TCG075VG Series Package Change Notification

Please accept this letter as an official notification of the packaging change of TCG075VG series due to paper gasket reduction. Only TCG075VG series will be affected by this notification.

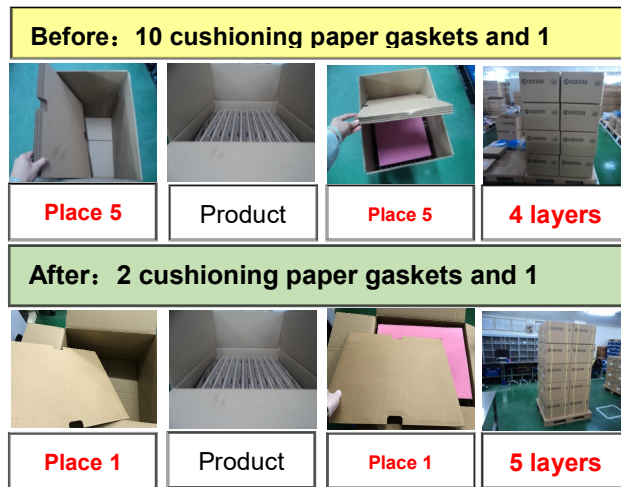
The number of paper gaskets change from 10 pieces to 2 pieces per box.

The height of each box is changed from 331mm to 290mm, other dimensions remain unchanged.

The quantity in each box remains unchanged.
